## PROPOSAL for DRAFT AMENDMENTS to the FUTURE REG.17 on HEAD RESTRAINTS

Transmitted by the expert from the Netherlands

Note: The text reproduced below was prepared by the expert from the Netherlands in order to create a new definition for a Front Contact Surface.

Figure – Demonstrating the ineffective part of head restraint

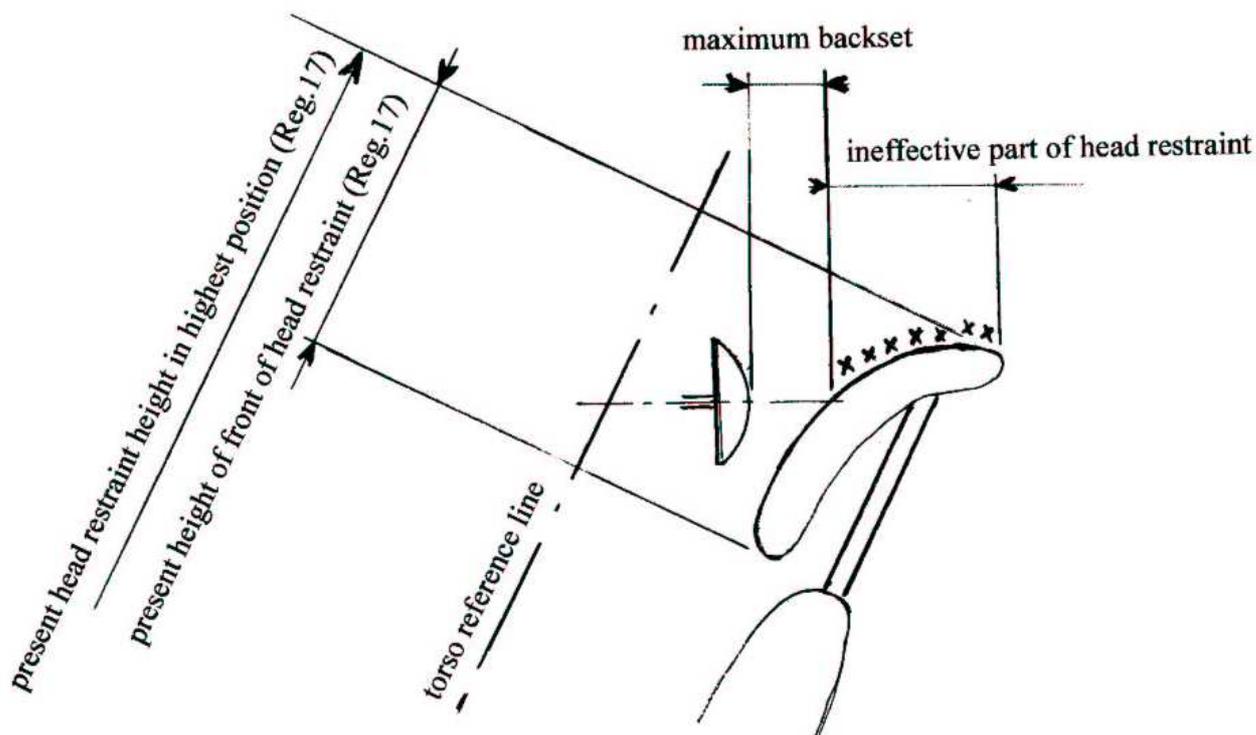
The present definitions of minimum required head restraint height and minimum height of the front of a head restraint seem to be insufficient because certain head restraint shapes are such that a part of the head restraint will not properly function in limiting the rearward displacement of the seated occupant's head. This is clearly demonstrated by the section indicated with crosses on the head restraint in the figure below.

This problem can be solved in two steps, being:

Step 1:

Define a “Front Contact Surface” of a head restraint having minimum outer dimensions that are based on requirements for width and height that already exist (resp. 5.6.1. and 5.10. of Reg.17) .

Step2:

Define a “Centreline of the head restraint” that, where situated within the “Front Contact Surface”, will have to fulfil the backset requirements.

**in Definitions, add the following two new definitions:**

- 2.x. Front Contact Surface of a head restraint means the front surface of the head restraint which is intended to catch the head of the seated occupant in order to limit rearward displacement of the head relative to the torso during a rear impact to the vehicle.
- 2.x+1 Centreline of a head restraint means the trace of the centre plane of the occupant (paragraph 2.10. of Commission proposal ECE/TRANS/WP.29/GRSP/2008/11) over the front surface of the head restraint.

- 5.5.x. Minimum area and location of a Front Contact Surface.  
When measured in accordance with Annex “New”:
- 5.5.x.1 a Front Contact Surface shall have at least a minimum area with borders that coincide with the intersections of the following planes with the head restraint:
  - two vertical longitudinal planes set at 85 mm on either side of the centreline of the head restraint,
  - two planes perpendicular to the torso line, 100 mm apart.
- 5.5.x.2 the top border of the Front Contact Surface shall reach to at least the minimum required height above the R-point that counts for the designated seating position.
- 5.5.x.3 the centreline of the head restraint within the Front Contact Surface shall fulfil the backset requirements.
